## 10.0 Steam and Power Conversion System

The information in this section of the reference ABWR DCD, including all subsections, tables and figures, is incorporated by reference with the following departures and supplements.

### 10.1 Summary Description

Figure 10.1-1 Reference Steam and Power Conversion System

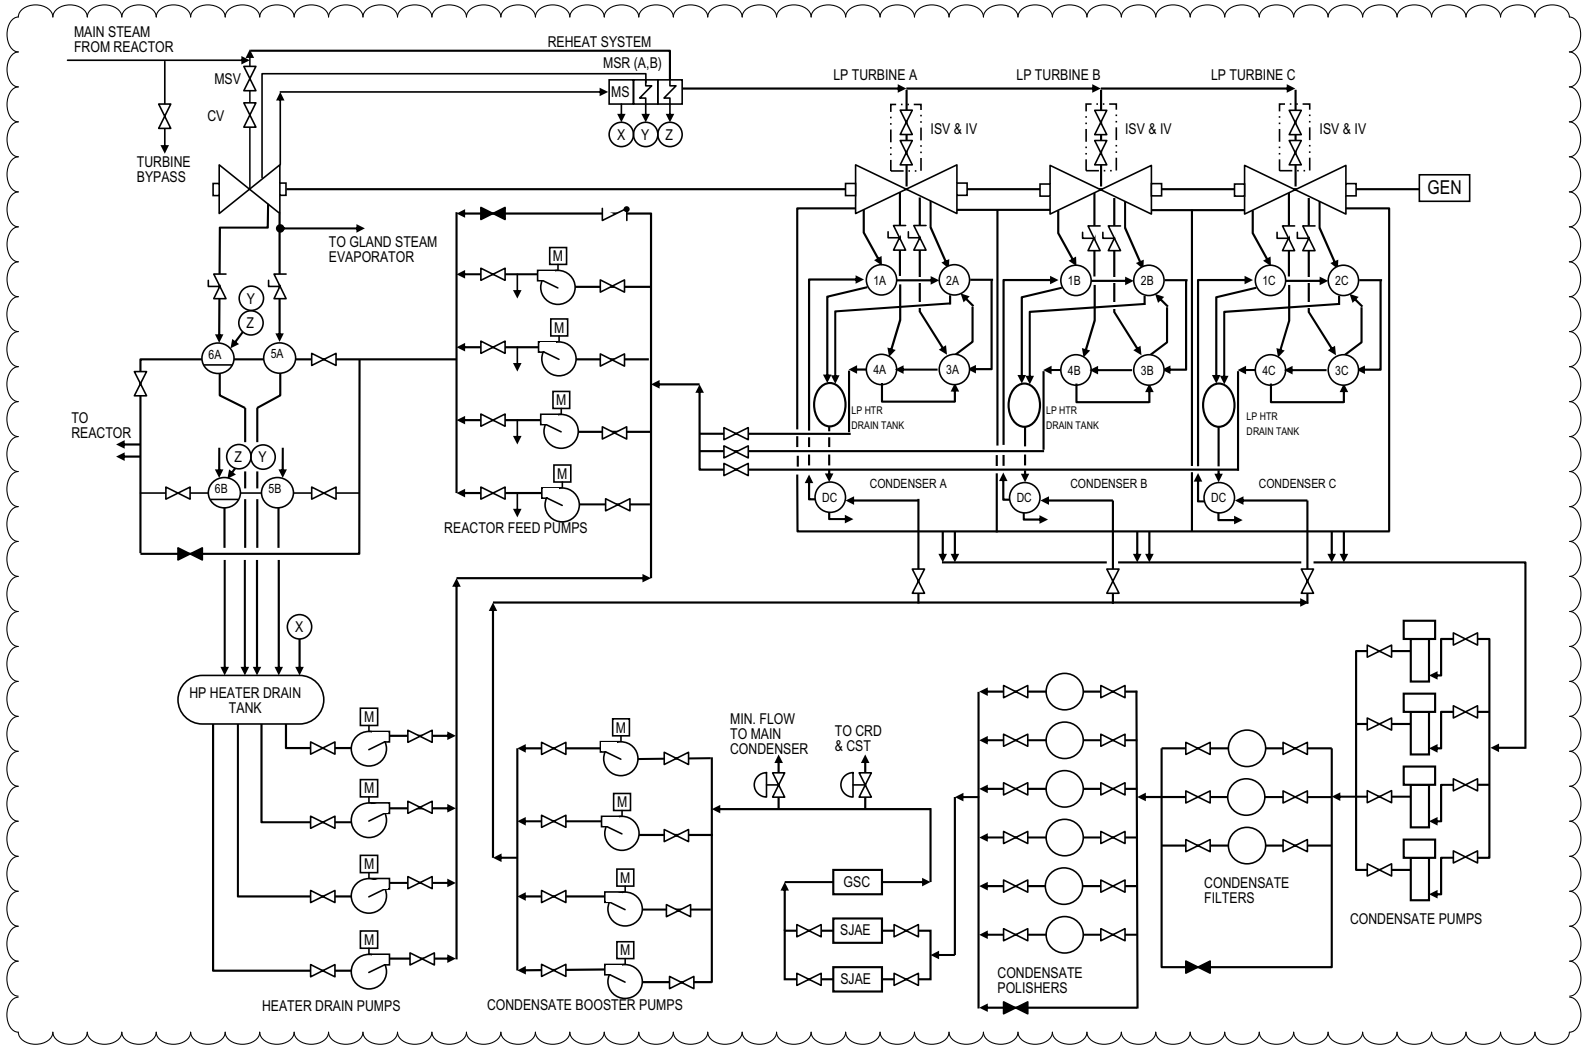
STP DEP 9.2-3 (Figure 10.1-1)

STP DEP 10.1-2 (Figure 10.1-1)

STP DEP 10.2-1 (Table 10.1-1, Figure 10.1-1)
